**Re: BHP Billiton Response to IEMA Letter on Deposition of Wastewater into Cell D, Long Lake Containment Facility (LLCF)**

ENR-SWP-PKWW-05 Wastewater and Processed  
Kimberlite Management Plan

Figure 2 – Long Lake Containment Facility and Associated Infrastructure

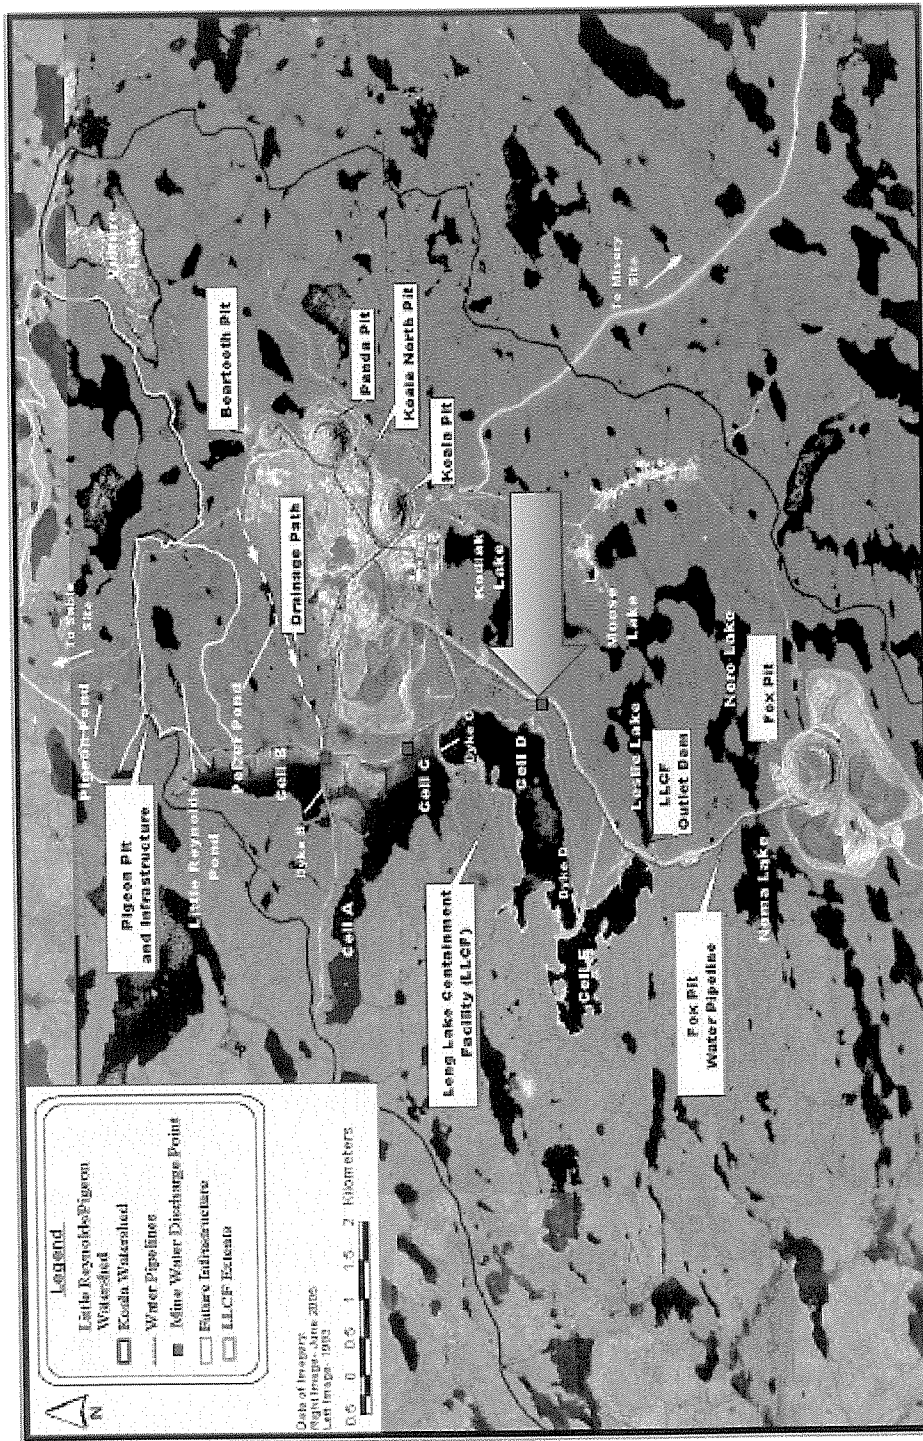
A mine water discharge point is clearly identified in the WPKMP, Figure 2, Long Lake Containment Facility and Associated Infrastructure for Cell D on the Fox discharge line (copy of Figure attached). It also should be noted that we are depositing wastewater and not fine processed kimberlite (FPK) into Cell D. In regards to fine processed kimberlite (FPK) and extra fine processed kimberlite (EFPK) as opposed to mine water the WPKMP states in Section 3.4.2 Option 3aM Objectives that: *“ Delay discharge of FPK to Cell D for as long as possible. If the use of Cell D can be delayed beyond 2014 there is a potential for a mined-out pit to become available for depositing processed kimberlite, thereby avoiding the storage of FPK in Cell D.”* On the above basis and the fact that water will not be released from the LLCF unless it meets the Licence discharge criteria we disagree with the Agency’s assessments of the facts.
